### **AMENDMENTS TO THE DRAWINGS**

REMARKS

FIG. 21

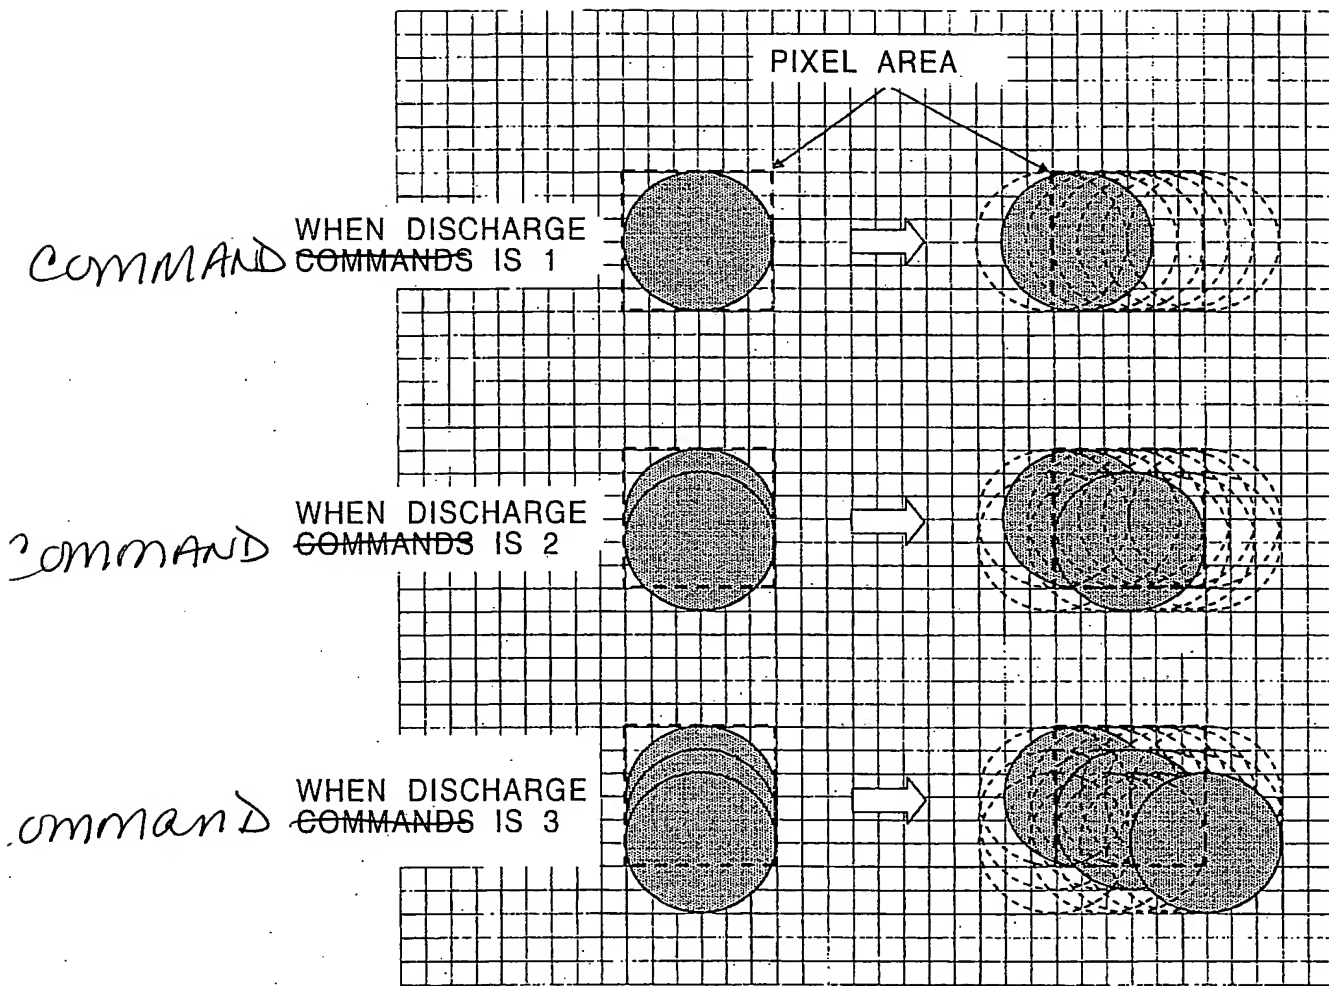
Sheet 2 includes Fig. 21 – Please change "Dpx POLARITY CHANGINVG SWITCH" to -- Dpx POLARITY CHANGING SWITCH -- and "Dpy POLARITY CHANGINVG SWITCH" to -- Dpy POLARITY CHANGING SWITCH --;
